STAFF REPORT

Executive Summary									
Hearing Body:	Millcreek Township Planning Commission								
Meeting Date and Time:	Wednesday, July 10, 2013	04:00 PM	File No:	2	8	3	6	8	
Applicant Name:	Steve Davies & Rick Plewe	Request:	Conditional Use						
Description:	8-lot Single-Family Planned Unit Development Subdivision								
Location:	3548 South Honeycut Road (1850-1860 East)								
Zone:	R-1-10 Residential Single-Family	Any Zoning Conditions?	Yes <input type="checkbox"/>	No <input checked="" type="checkbox"/>					
Community Council Rec:	Approval with Conditions								
Staff Recommendation:	Approval with Conditions								
Planner:	Spencer G. Sanders

The applicants have revised the proposal and is now requesting approval of a 7-lot, single-family PUD. The layout is similar to the previous one and more information on the current plans has been provided. Please refer to the Zoning Analysis Table in the ANALYSIS section of this report for more details.

PROJECT NO. 1303030
SITE PLAN
 CSP.01
 3 OF 8

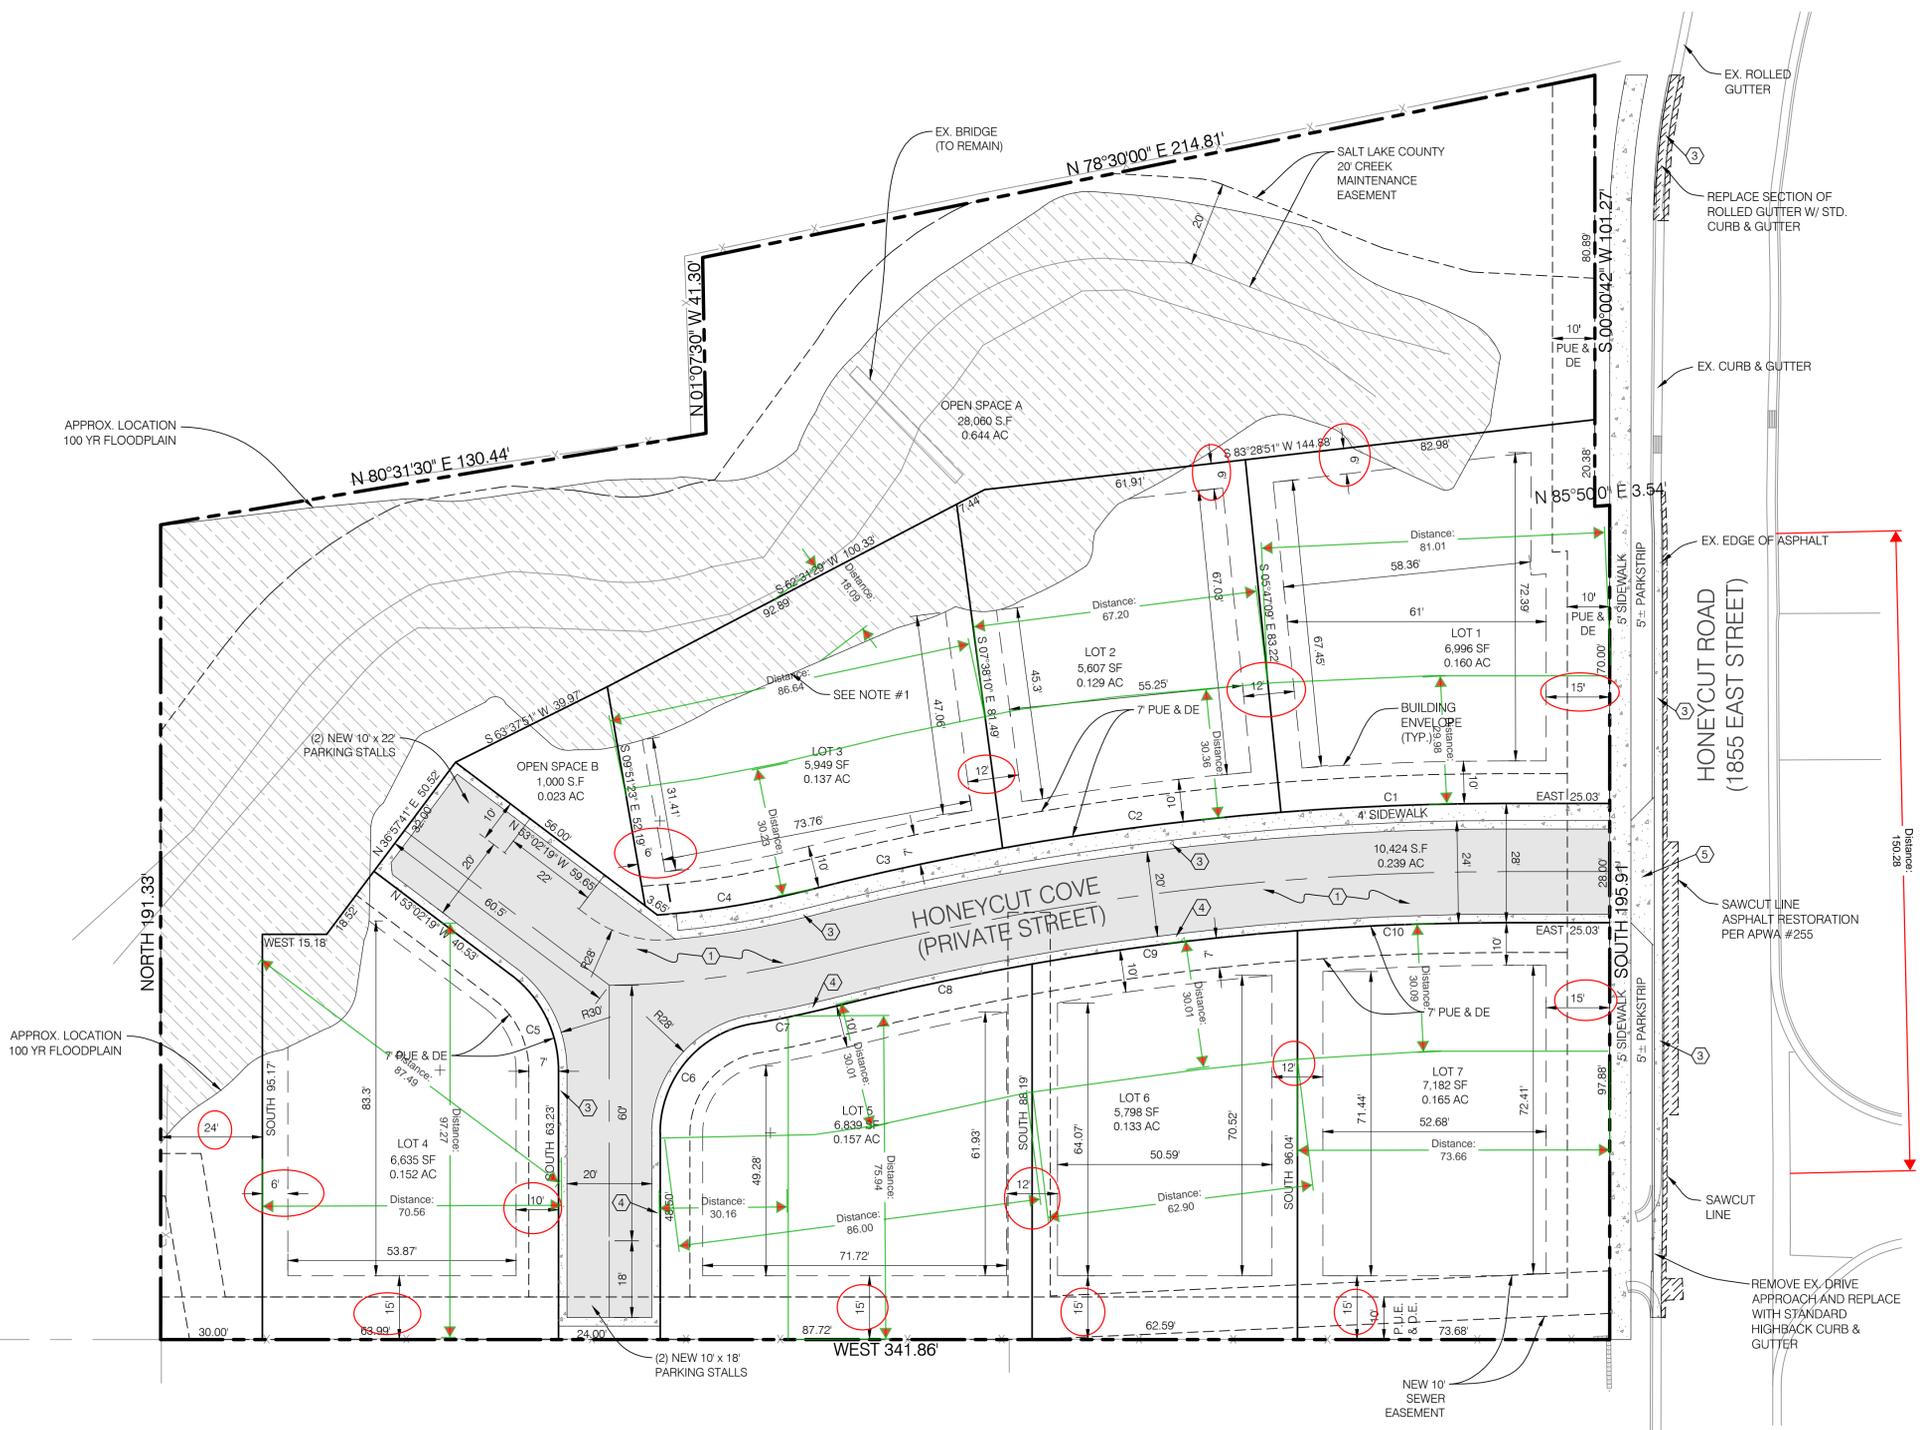
The applicant's current submittal shows the rear lot lines of lots 1-3 partially located within the FEMA floodplain boundary. In the case of lot three, almost the entire rear lot line is located approximately 18-20 feet into the floodplain. This places the rear lot line for Lot 3 very close to the edge of the ordinary high water level of the stream. (Please refer to the attached site plan.)

Staff has suggested to the applicants that these rear lot lines be relocated to the floodplain boundary. The slope from the floodplain boundary down to the creek is steep, particularly on Lot 3. It would be more appropriate to retain the floodplain area in the common open space rather than in individual lots. The applicants have agreed to make this change. Staff would recommend that that the rear setback for the homes on these lots be allowed to go to the new property line, with a small maintenance and construction easement, if needed, for home construction on these lots. Disturbance within this easement would be required to be restored.

The applicant is proposing no fencing between the lots and fencing only around the perimeter of the property with the adjacent residents. Staff supports this proposal, except staff is recommending that a low, open-style fence be placed along the revised rear lot lines of Lots 1-3 to help protect the slope down to the creek. Gates could be provided for access from the lots down to the pathway and seating areas planned along the creek. An open fence would allow visibility of the creek area from the rear of the homes, yet control the access and avoid damage to the slope over time with uncontrolled access. It will also make maintenance of the more sensitive lands the responsibility of the HOA instead of individual property owners.
